APPLICATION FOR AMENDMENT TO  
OPERATING LICENSE

Indian Point Unit No. 3

Docket No. 50-286

April 18, 1977

Figure 3.10-2a Fuel Rod Bow  $F_{\Delta H}^N$  Penalty Versus Region Average Burnup

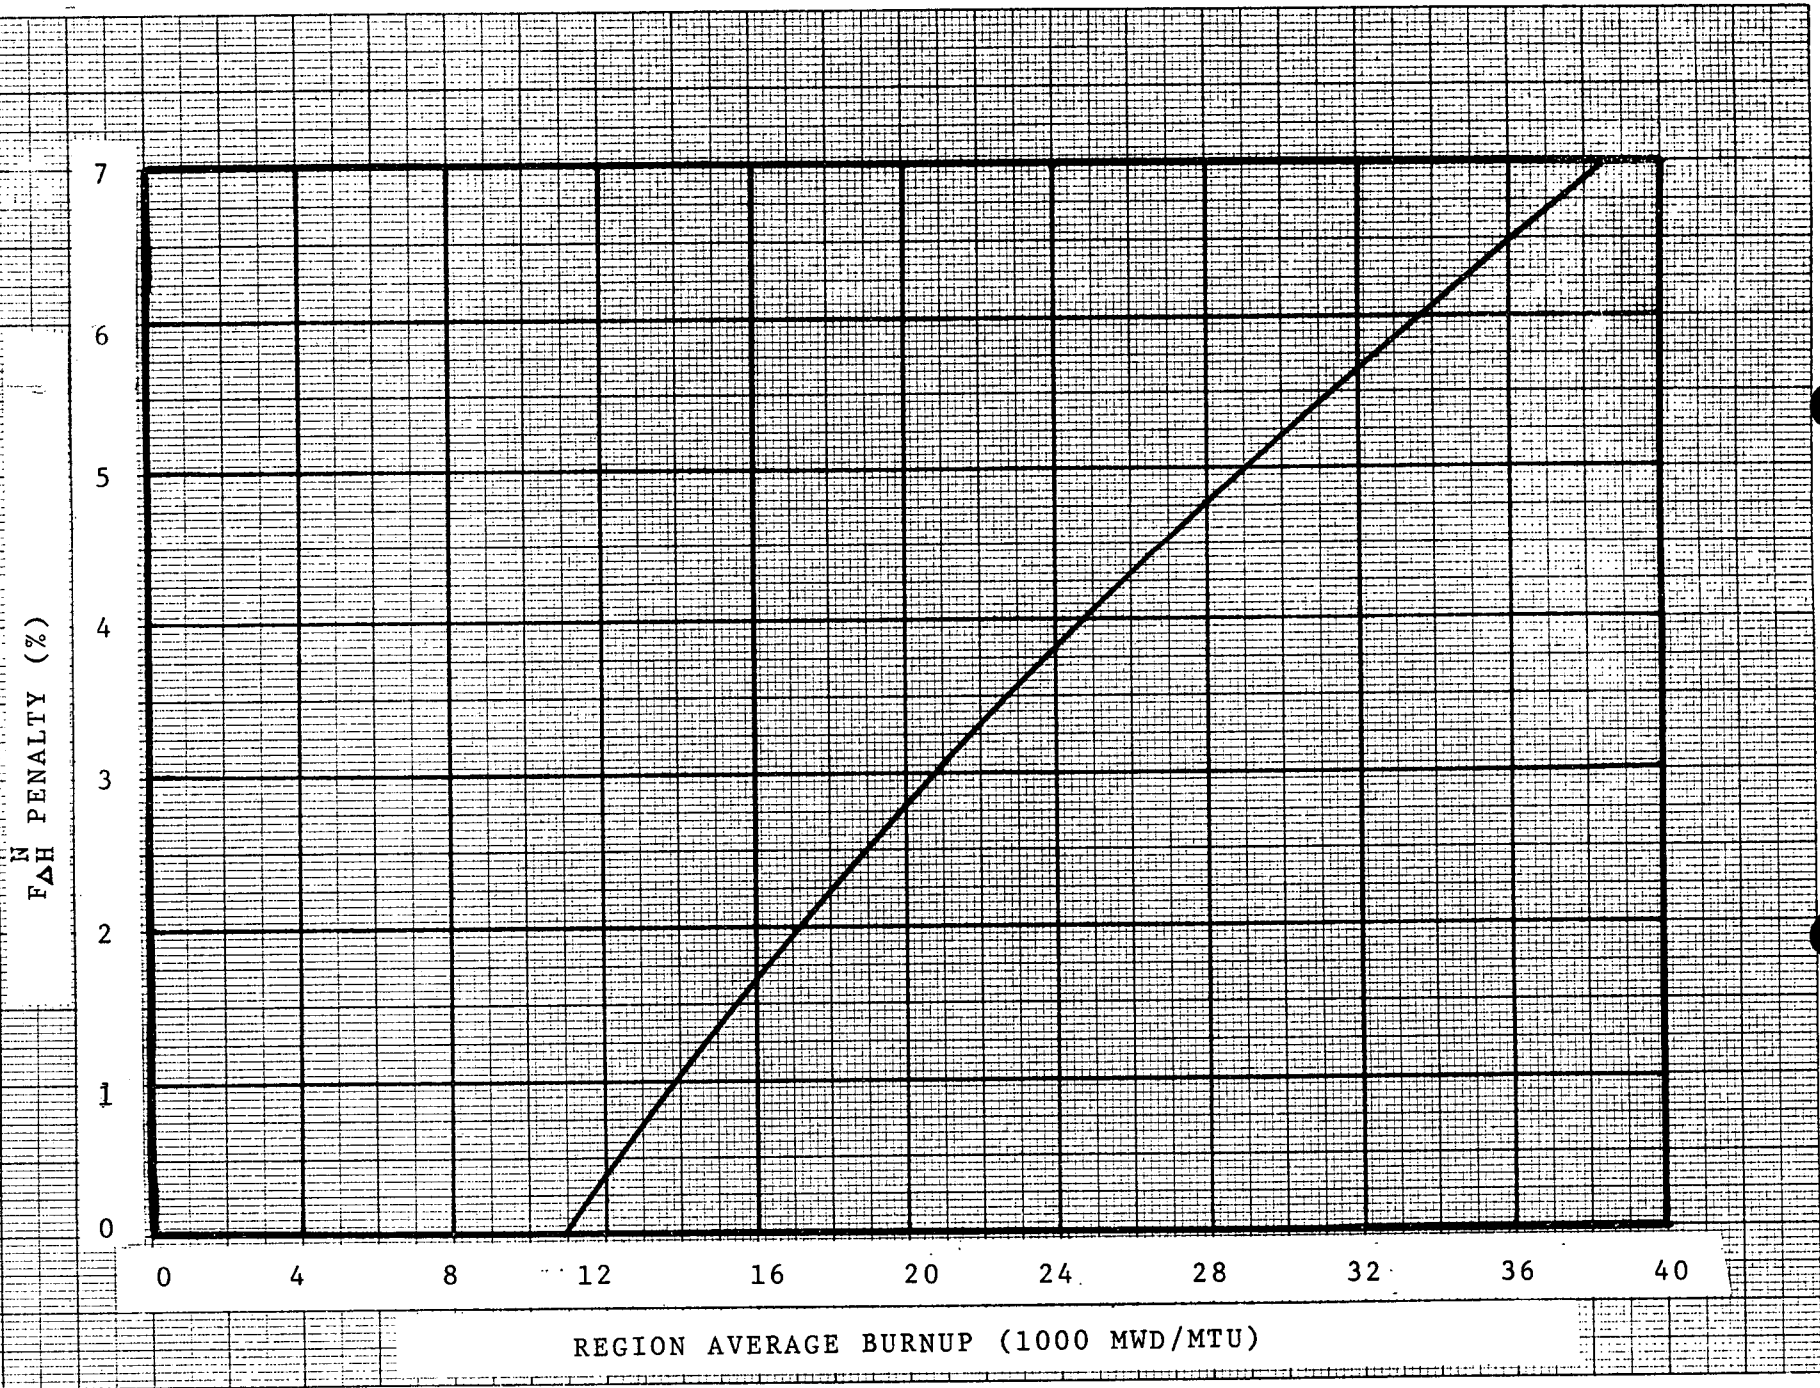
where P is the fraction of full power at which the core is operating. K(Z) is the fraction given in Figure 3.10-2 and Z is the core height location of  $F_Q$ . The  $F_{\Delta H}^N$  Penalty, as a function of region average burnup, is given in Figure 3.10-2a, and as further modified by specification 3.10.2.2.2.

The  $F_{\Delta H}^H$  limit (Specification 3.10.2.1) includes the effect of fuel rod bowing. This bowing has been observed in Westinghouse LOPAR fuel, and exceeds the design value assumed in the pitch reduction. Conservative models [3] have been developed to account for the effect of fuel rod bow on DNB. These models in conjunction with the generic DNB margins appropriate for Indian Point Unit No. 3 result in the  $F_{\Delta H}^N$  penalty versus burnup given in Figure 3.10-2a.

In no event shall the margins, due to the increased primary coolant flow and reduced  $T'$ , exceed the  $F_{\Delta H}^N$  penalty as given in Figure 3.10-2a.

The proposed changes to the Indian Point Unit No. 3 Technical Specifications, contained in Attachment A to this Application, would add the requirement of an additional  $F_{\Delta H}^N$  (enthalpy rise hot channel factor) penalty, as a function of region average burnup, and credit for measurable DNB margins to offset the  $F_{\Delta H}^N$  penalty. These requirements would ensure that the margins to departure from nucleate boiling identified in the NRC Interim Safety Evaluation Report on Effects of Fuel Rod Bowing on Thermal Margin Calculations for Light Water Reactors, Revision 1, February 16, 1977 are maintained.
